[Docket No. FAA-2012-1297; Directorate Identifier 2012-SW-100-AD; Amendment 39-17285; AD 2012-25-04]

Airworthiness Directives; Eurocopter France Helicopters

ACTION: Final rule; request for comments.

2012–25–04 Eurocopter France:

Figure 1 to paragraph (f)

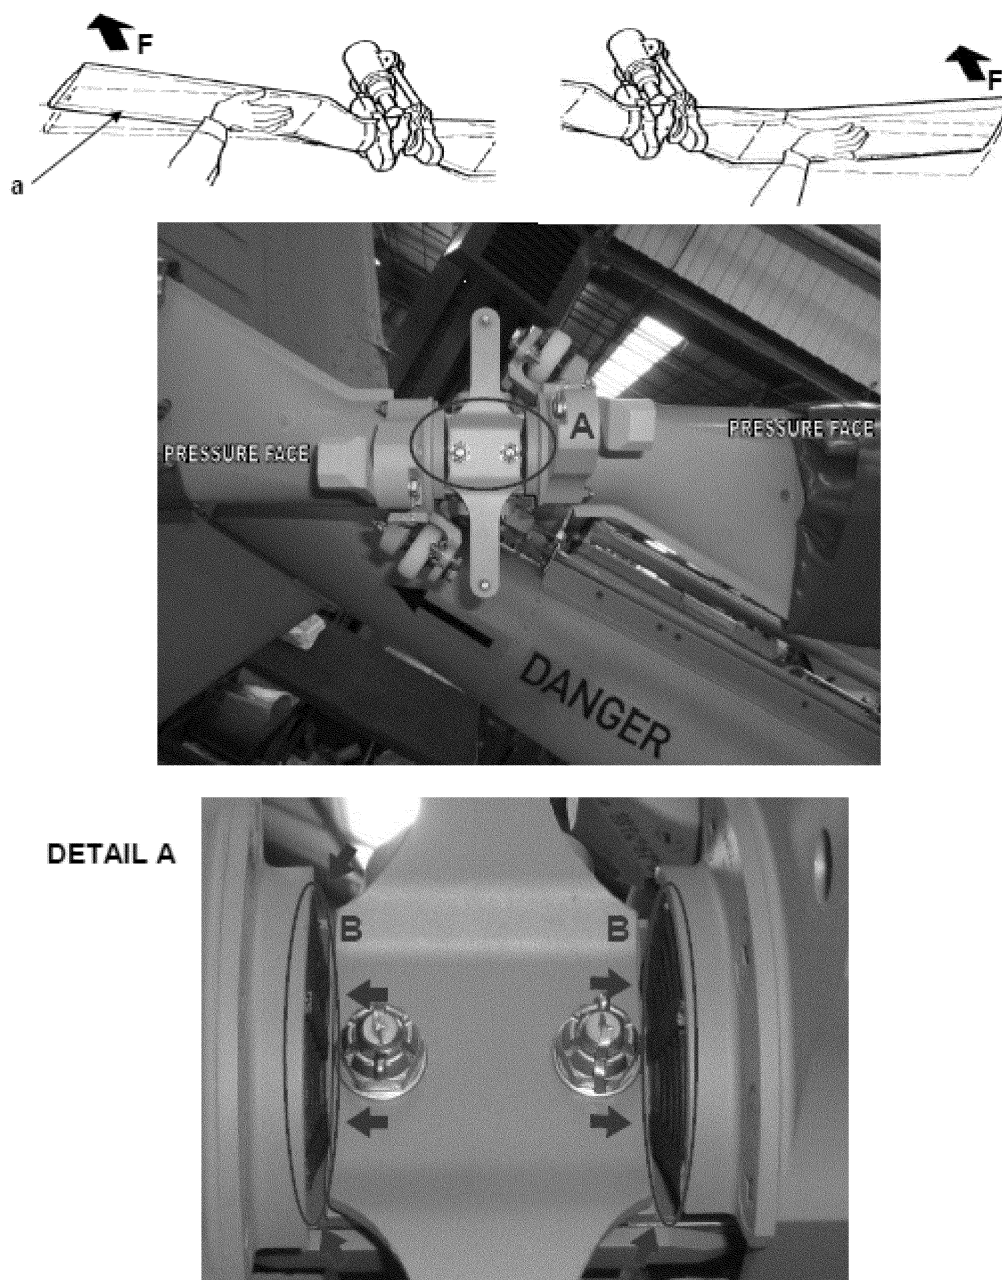
- (i) Position both tail rotor blades horizontally.
- (ii) Apply load (F) by hand, perpendicular to the pressure face of one tail rotor blade (a), as shown in Figure 1 to paragraph (f) of this AD, taking care not to reach the extreme position against the tail rotor hub. The load will deflect the tail rotor blade towards the tail boom.

(iii) While maintaining the load, check all the visible faces of the bearings (front and side faces) in area B of DETAIL A of Figure 1 to paragraph (f) of this AD for separation between the elastomer and metal parts, a crack in the elastomer, or an extrusion (see example in Figure 2 to paragraph (f) of this AD). A flashlight may be used to enhance the check.

(5) If there is an extrusion on any bearing, before further flight, replace the four bearings with airworthy bearings.

Figure 3 to paragraph (f)

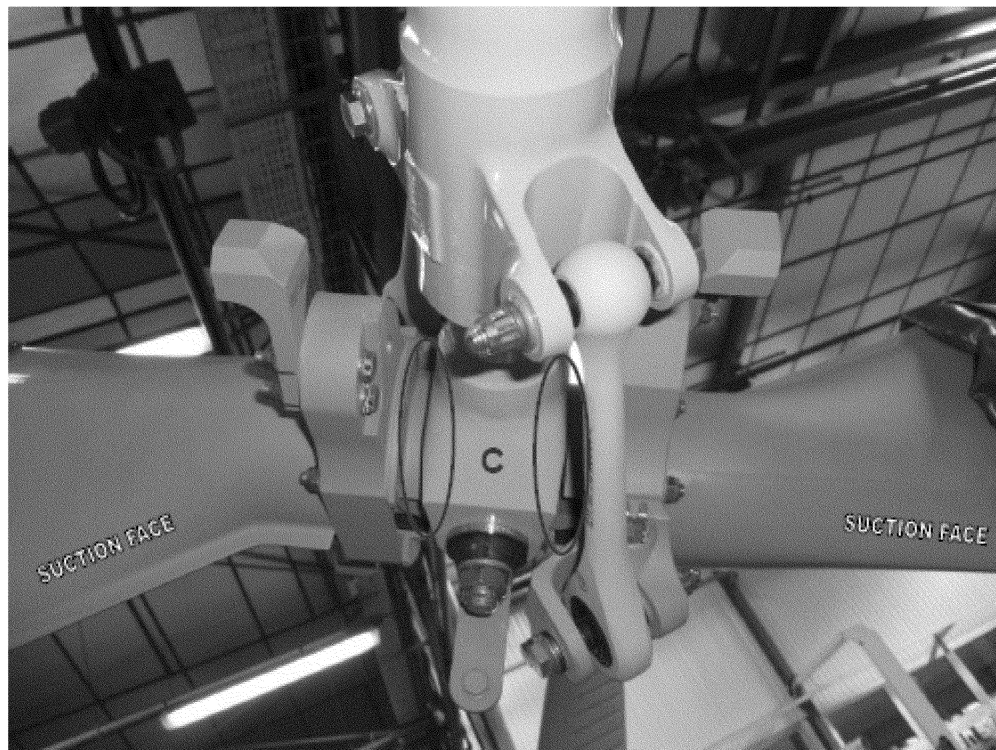
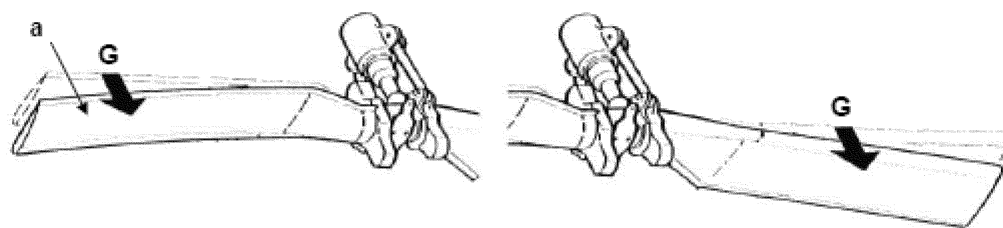
(v) Apply load (G) by hand perpendicular to the suction face of one tail rotor blade as shown in Figure 3 to paragraph (f) of this AD.

(vi) While maintaining the load, check visible faces of Area C as shown in Figure 3 to paragraph (f) of this AD for any extrusion. A flashlight may be used to enhance the check.

Figure 4 to paragraph (f)

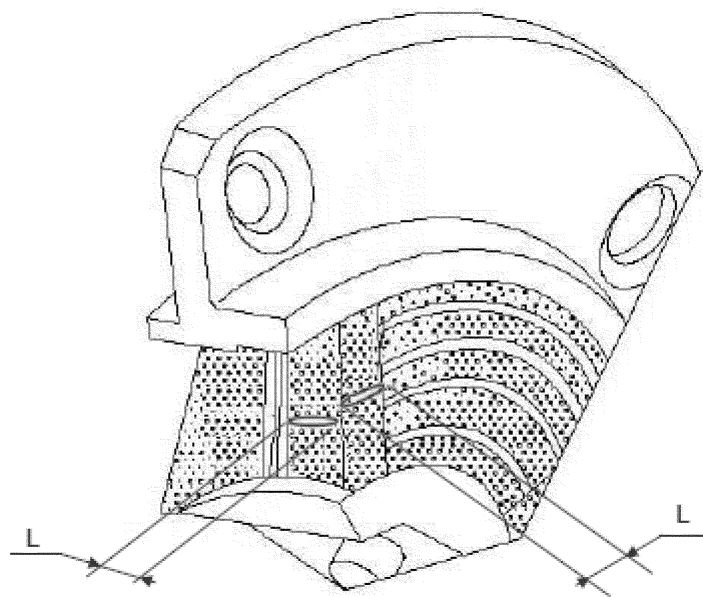
(6) If there is a separation or a crack on the pressure side bearing, measure the separation or the crack. If the separation or crack is greater than 5 millimeters (.196 inches) as indicated by dimension “L” in Figure 4 to paragraph (f), before further flight, replace the four bearings with airworthy bearings.
